SYDNEY NORTH PLANNING PANEL COUNCIL ASSESSMENT REPORT

Panel Reference	PPSSNH-412
DA Number	DA2023/0998
LGA	Northern Beaches
Proposed Development	Alterations and additions to the Freshwater Surf Life Saving Club building, including works to the 1935 heritage building, a new infill building, and substantial refurbishment and improvements to the rear building. Crown land - Part Lot 2797 DP820312, Lot 1 DP909023 & Lots 21 to 23 Section 2 DP975183 - Part Reserves D500403 and R64997 for Public Recreation - Freshwater Surf Life Saving Club
Street Address	The Esplanade, Freshwater Beach Reserve, Freshwater Beach
Applicant	Geoff Bonus (Bonus + Associates Architects)
Date of DA Lodgement	18/08/2023
Number of Submissions	22
Recommendation	Approval
Regional Development Criteria	Council related development over \$5 million
List of all relevant s4.15(1)(a) matters	Warringah Local Environmental Plan 2011 State Environmental Planning Policy (Resilience and Hazards) 2021 State Environmental Planning Policy (Transport and Infrastructure) 2021 Warringah Development Control Plan 2011 Warringah Coastal Lands Plan of Management 2002

Report prepared by:	DM Planning, Independent Consultant Planner
Repor

Figure 5. Concept Plan 11 Freshwater Sand Dunes (source: Coastal Lands POM)

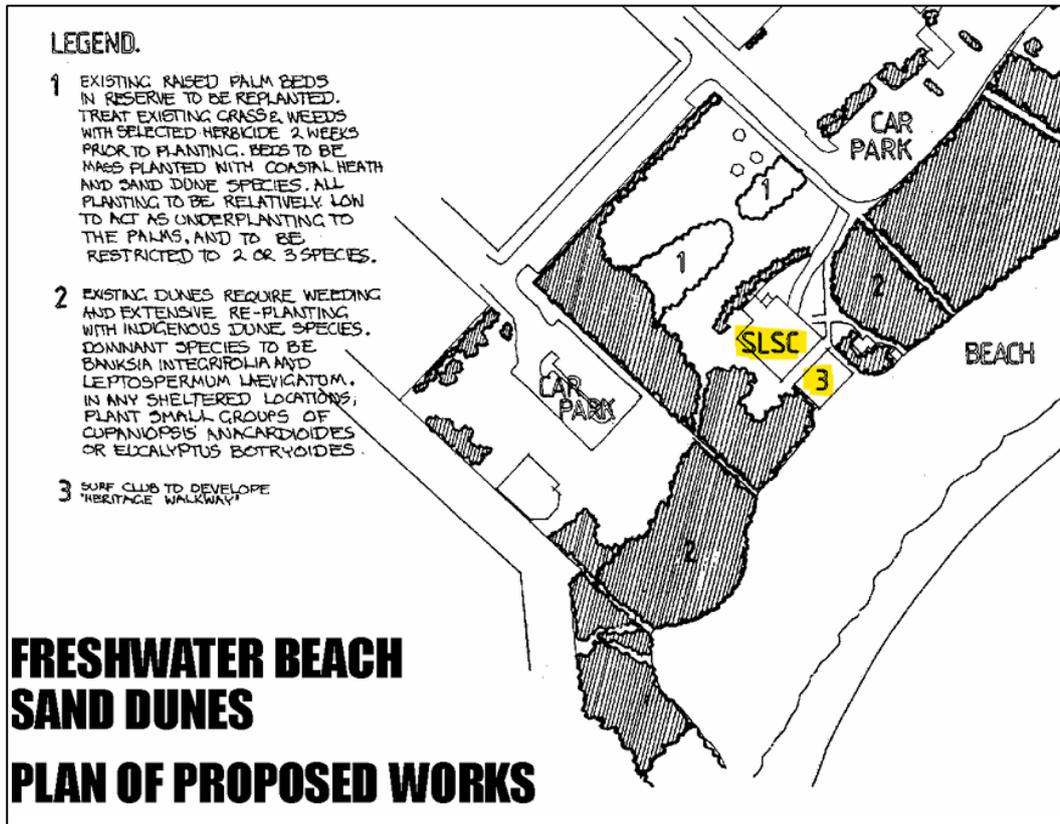
Coastal Lands POM requirement	Comment:
<p>Master Plan 4 and Concept Plan 11 –</p> <p>The Master Plan 4 and Concept Plan 11 note that dune restoration is to be undertaken for Freshwater Beach. The master plan notes that the park and dune area surrounding the FSLSC is to undertake restoration, with these areas more specifically identified in the concept plan.</p> <p>The concept plan also identifies the surf club as being subject to developing a 'heritage walkway'.</p>	<p>The proposed works for the surf club are not identified on the concept plan and will not impact the dune areas.</p> <p>The concept plan identifies existing dune areas (labelled "2" in Figure 5 above) that will require weeding and extensive re-planting. One tree will be removed from this area to accommodate the western extension (supported by Arborist Report). Replacement planting including <i>Banksia Integrifolia</i> is proposed elsewhere (shown in Landscape Plans).</p> <p>The proposal includes a double-height infill building that will display the Freshwater SLSC artefacts and memorabilia within a multipurpose space. This part of the proposal aligns with the heritage walkway concept.</p>
